CNL-14-039

Browns Ferry Nuclear Plant, Units 1, 2, and 3
Renewed Facility Operating License Nos. DPR-33, DPR-52, and DPR-68
NRC Docket Nos. 50-259, 50-260, and 50-296

Subject: **Radiological Emergency Plan Revision**

Enclosure 1
Summary of the Changes and Analysis for Radiological Emergency Plan (REP)
Revision 103

**FIGURE B-4
OPERATIONS SUPPORT CENTER
Plant Office Building Elevation 706**

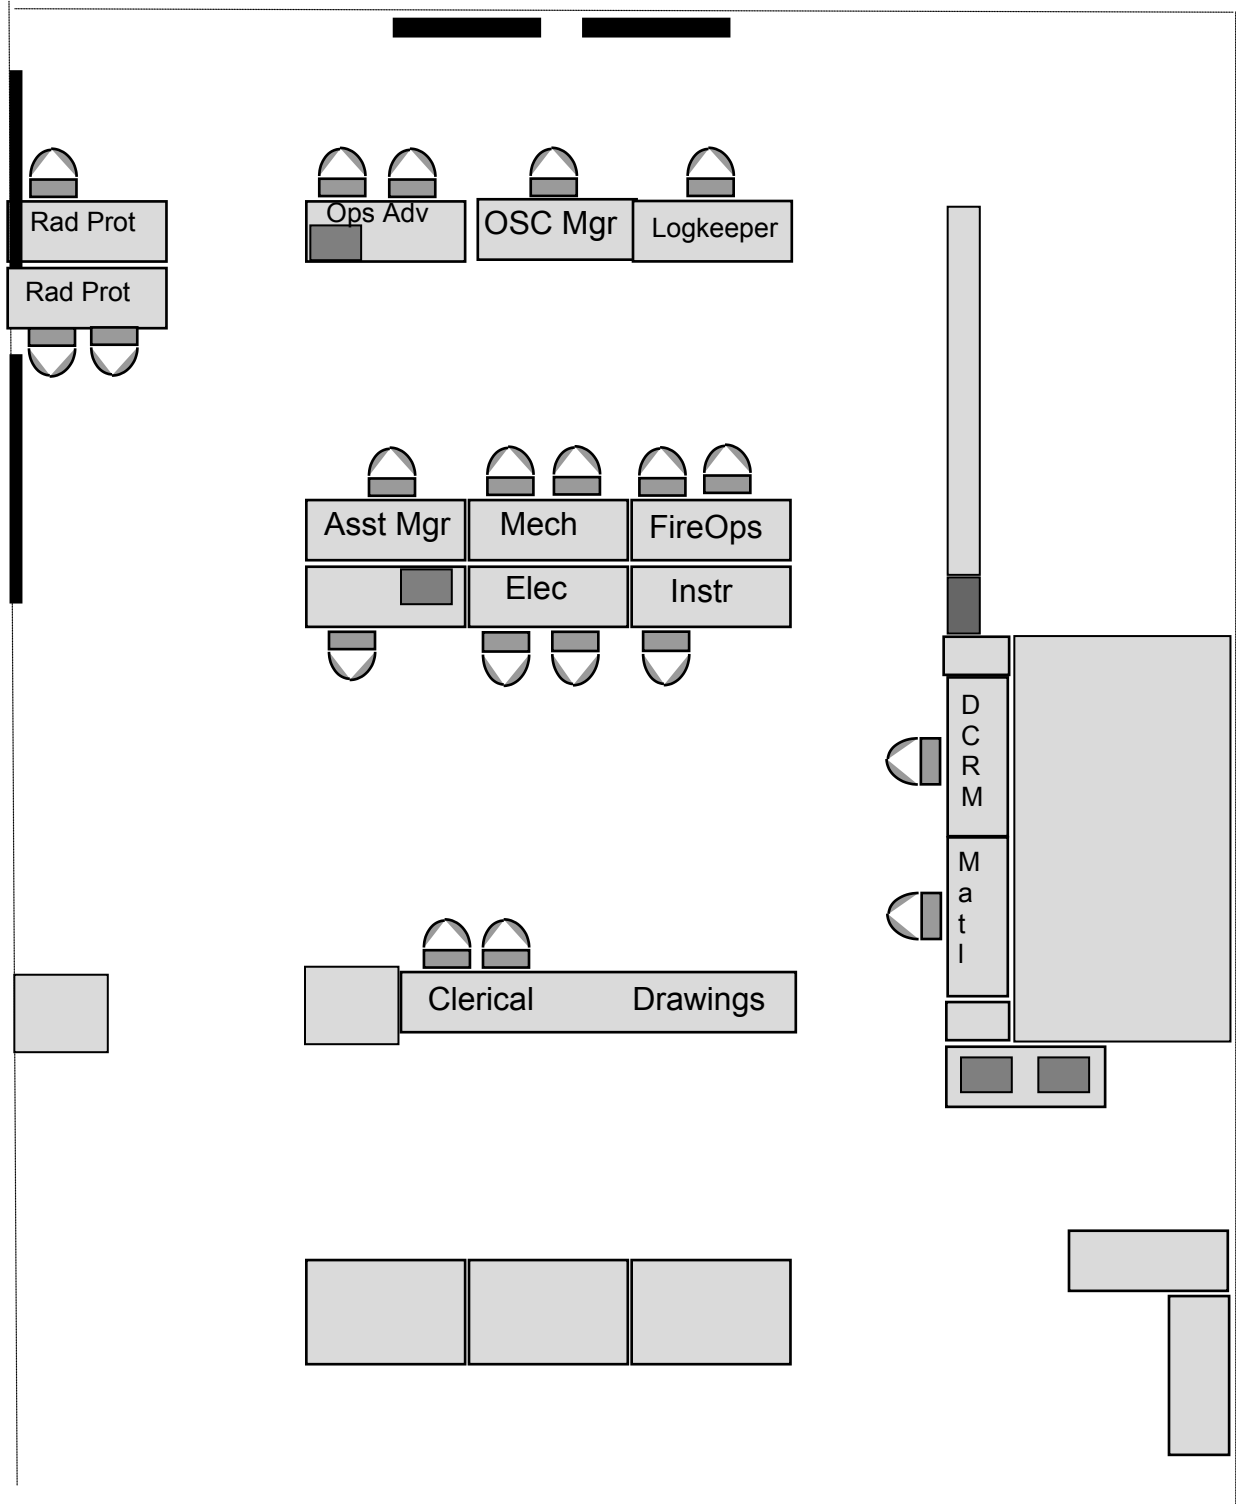
REP, Appendix B	Removed MSS label from fig B-4	The proposed activity does continue to comply with the requirements. The proposed activity does not constitute a reduction in effectiveness (RIE). This change is considered minor and has no effect on any planning standard or timely implementation of the REP.
REP, Appendix C	Updated EAL values for EALs 1.1.5 and 1.3.5 based on approval of calculation TIRPS162 R14	The change does not alter or change the objective and purpose of the EAL. The proposed activity does continue to comply with the requirements. The proposed activity does not constitute a reduction in effectiveness (RIE). This change has no effect on any planning standard or timely implementation of the REP.
REP, Appendix C	Updated Table 7-1based on approval of calculation WBNTSR115 Rev 7;	The change does not alter or change the objective and purpose of the EAL. The proposed activity does continue to comply with the requirements. The proposed activity does not constitute a reduction in effectiveness (RIE). This change has no effect on any planning standard or timely implementation of the REP.
